Product / Process Change Notification (PCN)	
<input checked="" type="checkbox"/> Major Change <input type="checkbox"/> Minor Change	
PCN Number: PCN_IndFCLP_20240625 Affected Series: WE-FCLP Affected Order Codes: 744869161xxx PCN Date: 2024-03-25 (YYYY-MM-DD) Effective Date: 2024-06-25 (YYYY-MM-DD)	Change Category: <input type="checkbox"/> Equipment/Location <input type="checkbox"/> General Data <input type="checkbox"/> Material <input type="checkbox"/> Process <input checked="" type="checkbox"/> Product Design <input type="checkbox"/> Shipping/Packaging <input type="checkbox"/> Supplier <input type="checkbox"/> Software
Contact: Product Management Phone: +49 (0) 7942 - 945 5001 Fax: +49 (0) 7942 - 945 5179 E-Mail: pcn.eisos@we-online.com	Datasheet Change: <input checked="" type="checkbox"/> Yes <input type="checkbox"/> No Attachment: <input checked="" type="checkbox"/> Yes <input type="checkbox"/> No

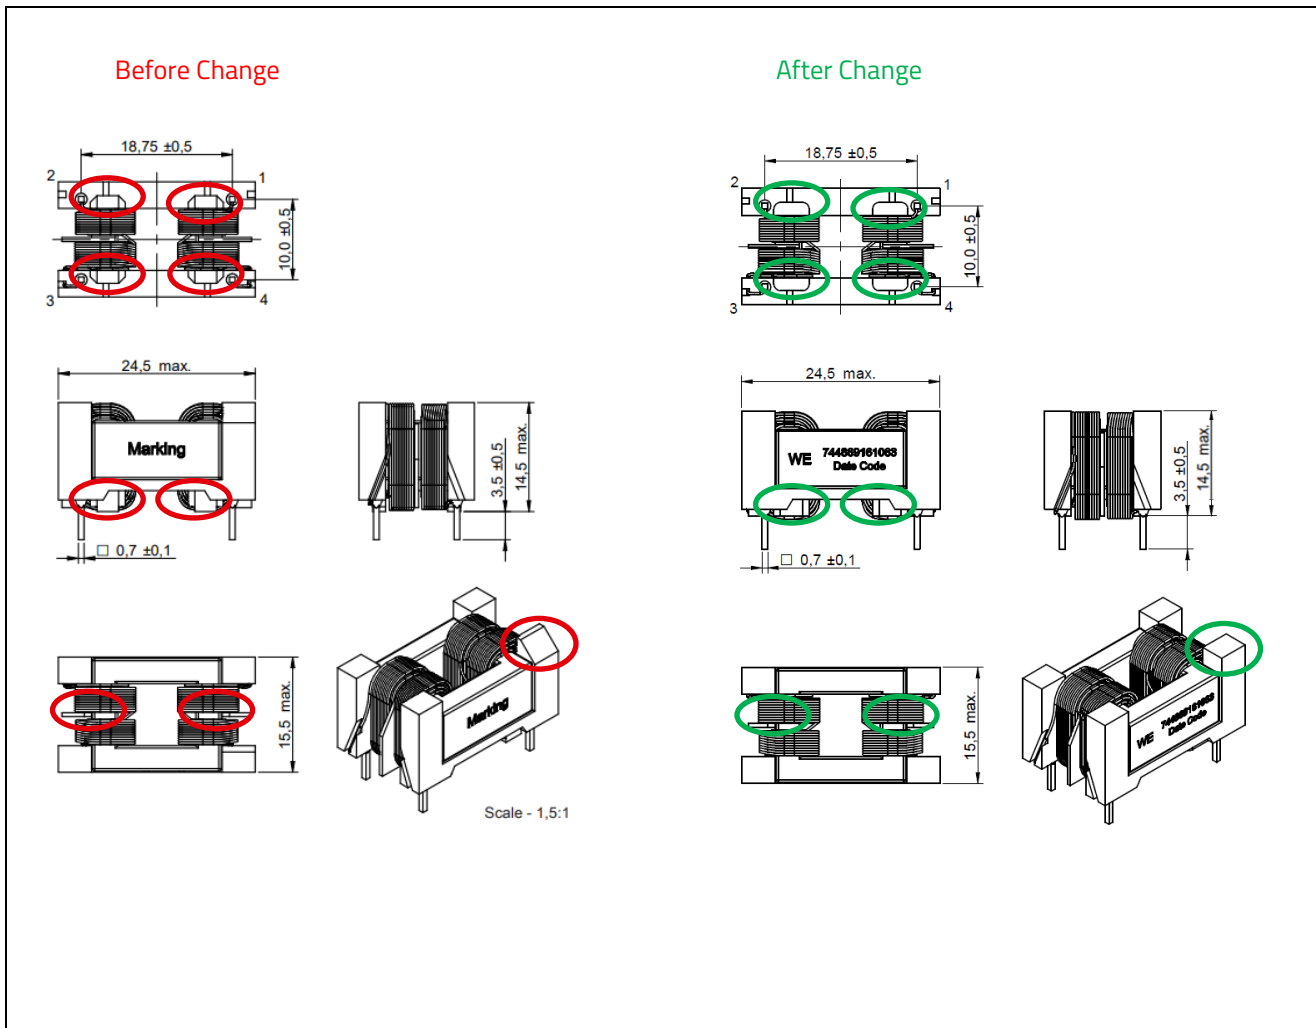
Description of Change: In order to enhance the product reliability, Würth Elektronik will change the base design. There will be no change in the outer form, fit, function, quality or reliability of the product.	
Detail of Change: To improve the winding of the component Würth Elektronik will adjust the base design. <ul style="list-style-type: none"> - Size of the spacers on the bottom of the part - Size of the spacers between the wire - Marking of Pin 1
